Subject: Requesting Class II permissive change for FCC ID: 2AXJ4HX510V2

The purpose of this letter is to request a Class II Permissive change for FCC ID: 2AXJ4HX510V2, original granted on 01/11/2024.

P10 Schematics the transformer model change from DG36001 G to HST-36001DAR.

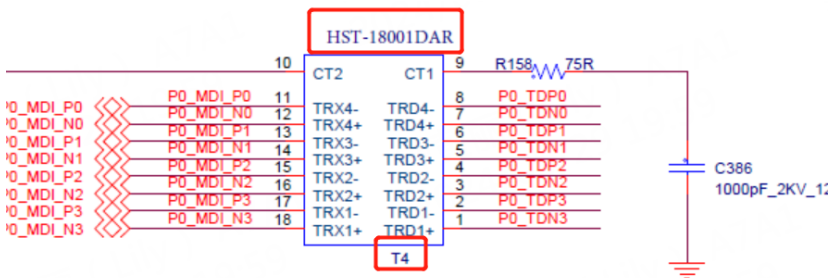
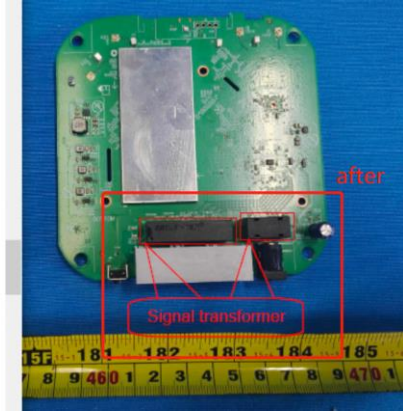
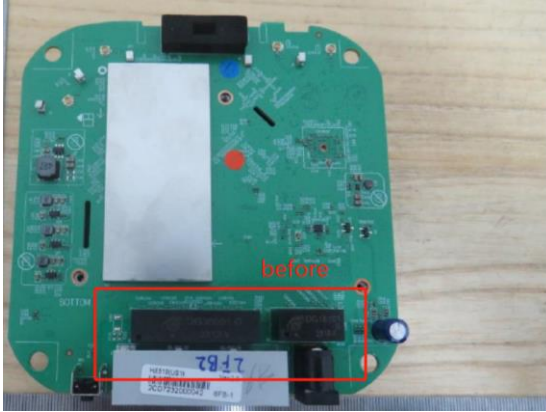
1. Model HX510 changed the signal transformer of the network port. (Update transformer model number.)

P10 Schematics the transformer model change from DG18101 G to HST-18001DAR.

This C2PC is compliance with 4 items in KDB 178919 D01v06 section III. D.

- 1) The new chip component is pin-for-pin compatible.
- 2) The new chip has the same basic function as the old chip, from an external perspective (internal circuitry may differ).
- 3) No change in radio parameters has occurred.
- 4) The same conditions apply when a small area (approximately the same area as the chip) of the PCB is replaced with an equivalent chip.
